4TH STREET BUILDING RENOVATION
209 NORTH 4TH STREET
ST. LOUIS, MO 63102

REV.	DATE	ISSUE
	07-15-10	PERMIT SET
△	09-13-10	REVISION 1

SHEET NUMBER
A2.0
BASEMENT & 1ST FLOOR PLAN

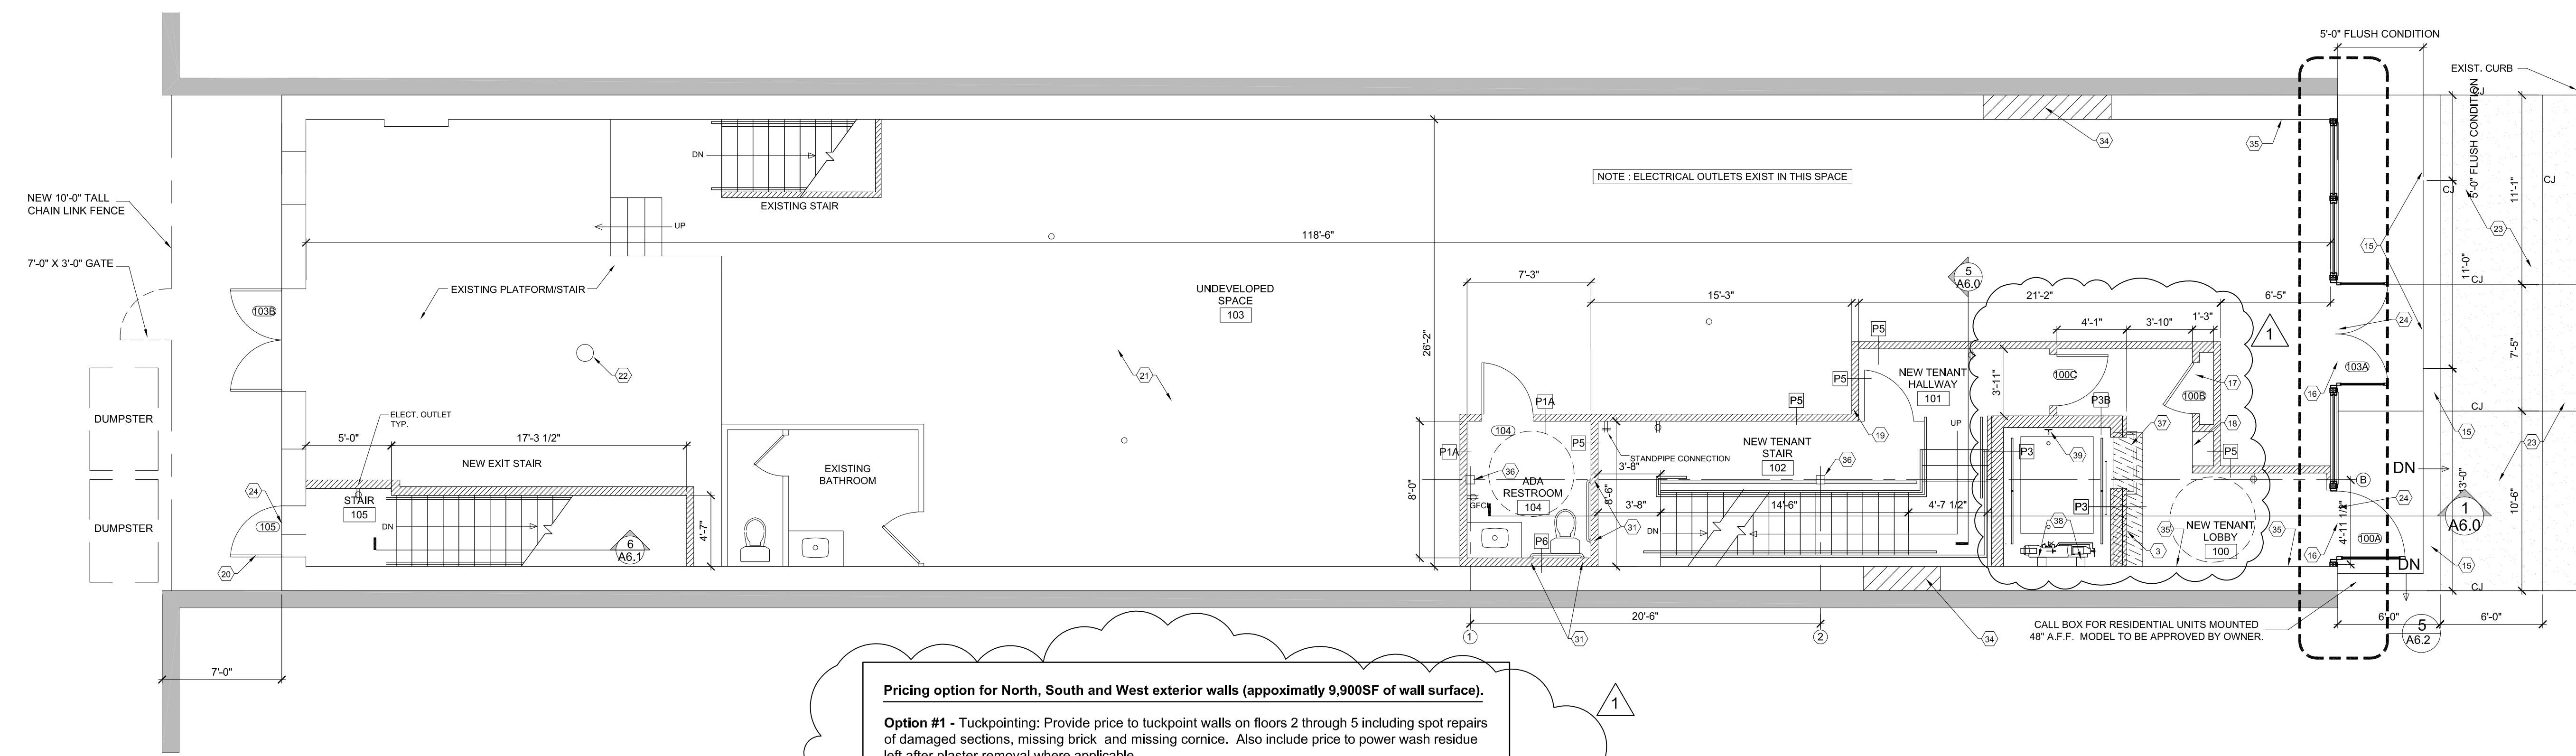
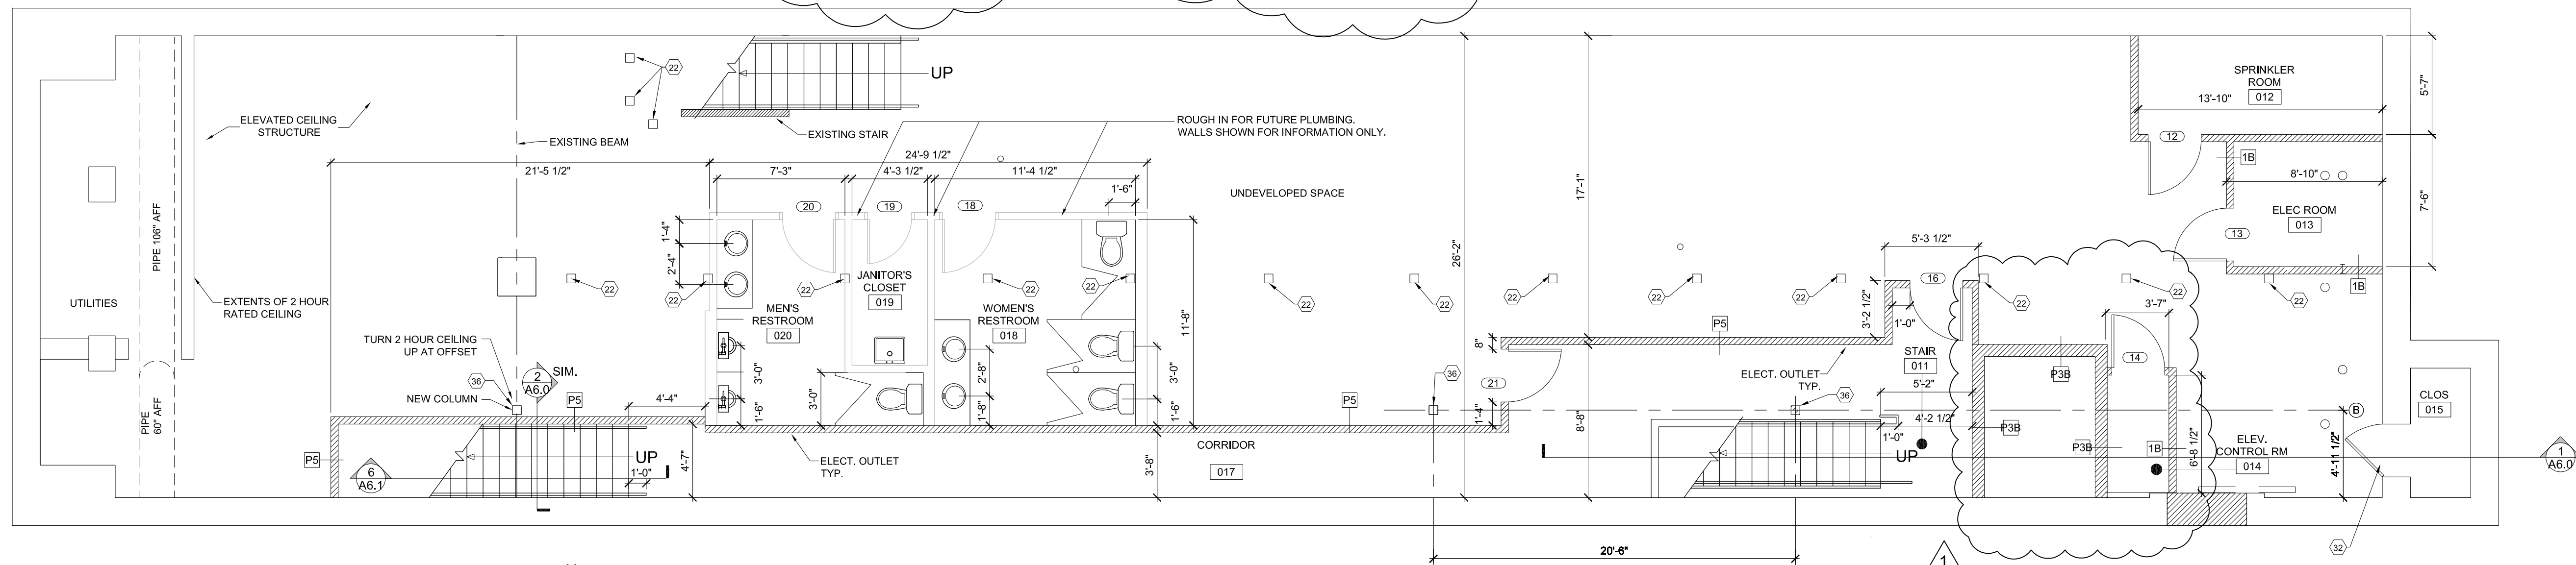
Pricing option for North, South and West exterior walls (approximately 9,900SF of wall surface).

Option #1 - Tuckpointing: Provide price to tuckpoint walls on floors 2 through 5 including spot repairs of damaged sections, missing brick and missing cornice. Also include price to power wash residue left after plaster removal where applicable.
Unit Price: Provide square foot unit price for tuckpoint masonry

Option #2 - Drywall: Provide price to furr and drywall walls on floors 2 through 5 per detail 3A/A6.01. Where plaster remains, cut a groove for furring strips.
Unit Price: Provide square foot unit price for furred drywall per detail 3A/A6.01
